ALERT SERVICE BULLETIN
REVISION NOTICE
Bell Helicopter**TEXTRON**
A Subsidiary of Textron Inc.

SUBJECT: **REVISION "A" TO ALERT SERVICE BULLETIN 206-06-107:
(VERTICAL FIN SUPPORTS 206-031-417-003/-007 AND 206-031-418-
001/-005, INSPECTION OF)**

NO. 206-06-107

SUBJECT: VERTICAL FIN SUPPORTS 206-031-417-003/-007
AND 206-031-418-001/-005, INSPECTION OF

Figure I: Primer Application for Vertical Fin and Support

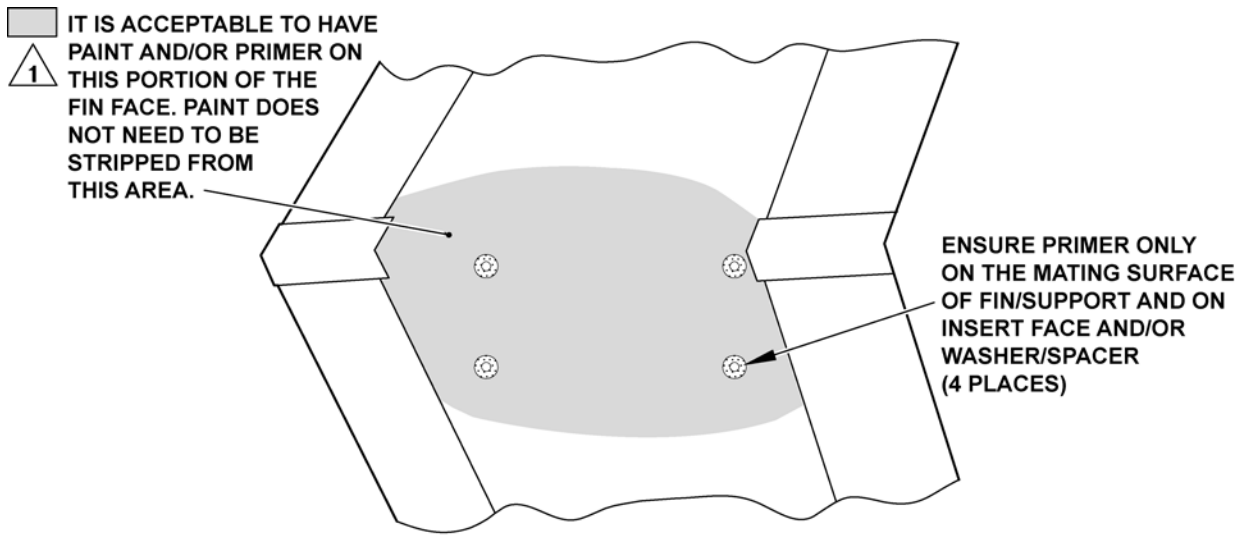
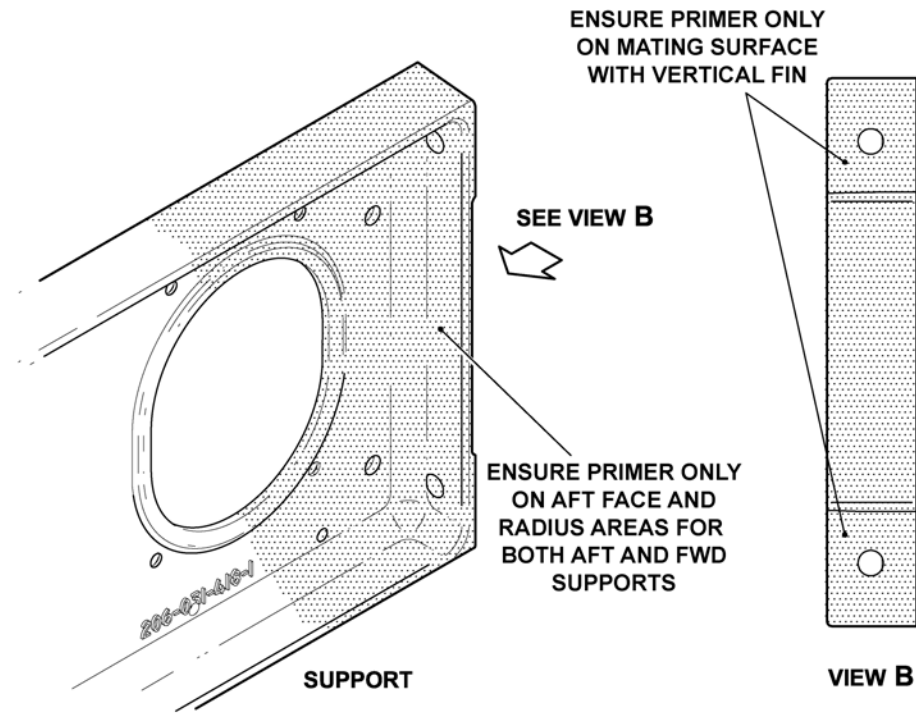
Revision "A" to this bulletin introduces a minimum torque value of 50 in-lbs (5.65 Nm) to be used for the torque check. In addition, the steps from tables 2 and 3 have been re-numbered. As a minimum requirement on the vertical fin, primer only in the area of the mating surface of fin/support, reference revised Figure 1.

6. Inspect the supports and fin for the presence of paint coating at the indicated areas on Figure 1. Do not remove paint now, record your findings and proceed with the step 7 (with Type 2 fin only) and 8 or 9 depending on what you have recorded on Table 2 or 3 as applicable.

- b. Remove all organic finish (primer and paint coating) at the areas indicated on the Figure 1. Reference the BHT-ALL-SPM for paint removal and primer application.

1 If paint is present in this area, it is suspected that the washer (spacer) and mating surface has paint coating. In this case, the fin shall be removed for verification.

This surface shall have primer coating only. Remove all paint coating, if present. Refer to BHT-ALL-SPM.

Figure II: Vertical Fin Type 2 Doubler and Washer (Spacer) Stack-Up Gap Check

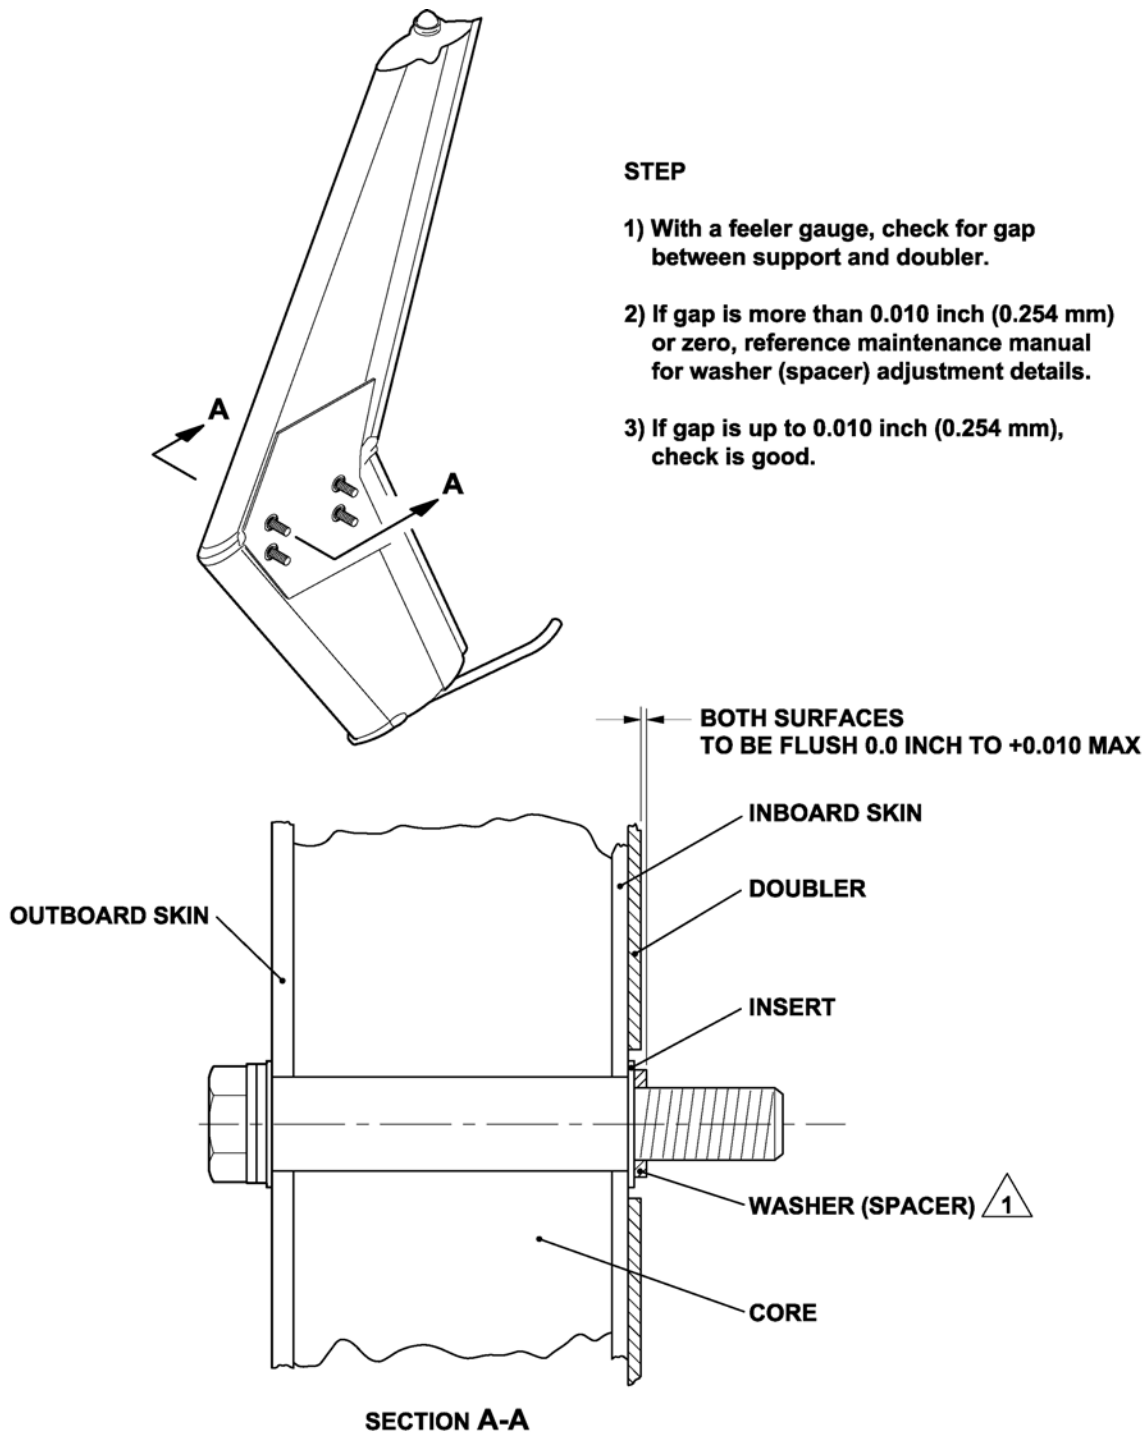
7. Perform gap check. Reference Figure 2. Record your findings and proceed with step 8 or 9 depending on what you have recorded on Table 3.
8. If the torque was within limits (not below 50 in-lbs (5.65 Nm)), no presence of paint and the gap check (Type 2 fin) was good; perform a 10 X visual inspection of the supports in the area of the fin attaching hardware.

- 1) If no damage is found, proceed to step d.
 - 2) If any damage of the potted insert is detected, contact Product Support Engineering.
 - d. If the fin installed is of Type 2, ensure the correct washers (spacers) are installed between the supports and the fin inner skin. Refer to the Figure 2 Section A-A. For washers (spacers) inspection and installation procedure, refer to the BHT-206A/B-SERIES-MM, chapter 53.

1 FOR WASHER (SPACER) INSTALLATION, REFER TO MAINTENANCE MANUAL.
